31-35 Victoria Parade, Fitzroy - Druids Site - DFP-228

**Druids Site Development (DSD), St Vincent's Hospital, 31-35 Victoria Parade, Fitzroy (Council reference: PPE22/0228)**

# Urban Design Formal Referral Response

Figure 1. Proposed indicative tree locations (Not to Scale)

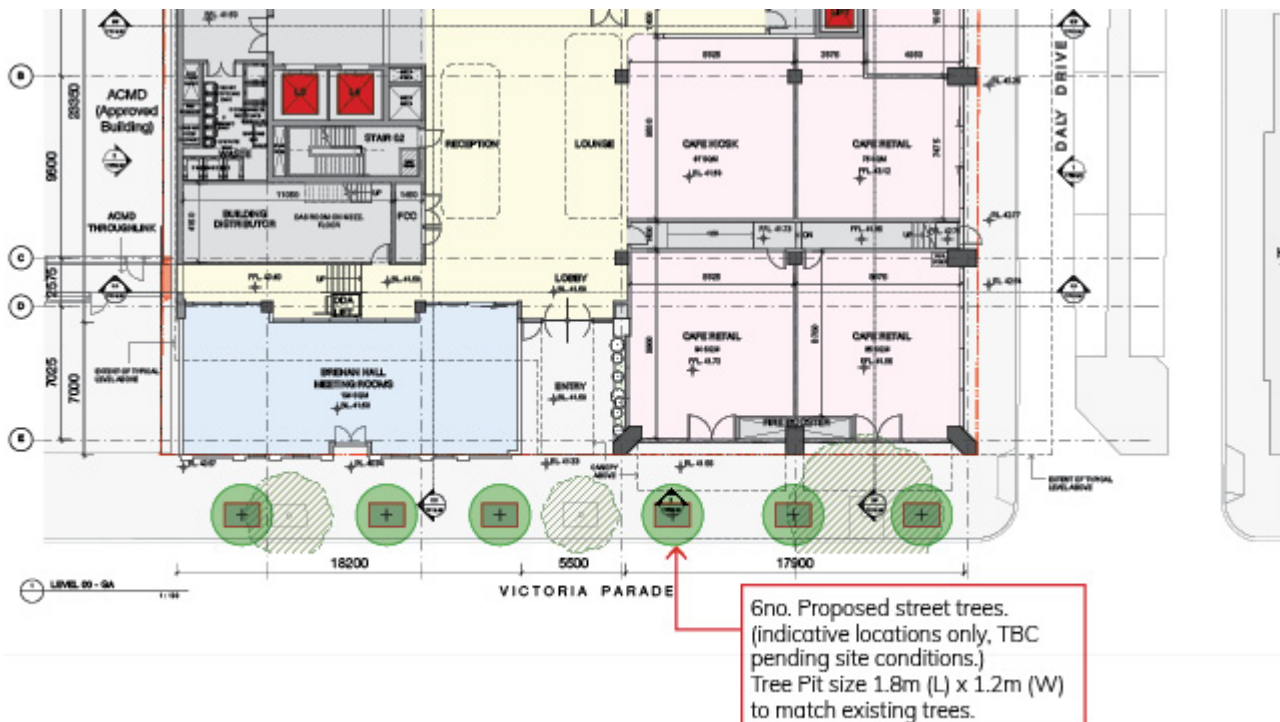
- In order to maximise the potential canopy coverage of this location, it is recommended that 6no. new street trees are planted along the Victoria Pde footpath.

- The developer would be requested to fund the planting of the new street trees along Victoria Pde in the indicative locations shown in Figure 1 below, noting the following:

- The applicant is requested to contribute to the cost of planting 6no. new street trees, which would cover tree sourcing, planting and 2 years of establishment maintenance.

- Provide new permeable resin bound pebble finish to 6no. new tree pits.
  - An estimate of the total cost for the trees, planting, and surface finish would be \$10,461 (plus GST), with the following breakdown:
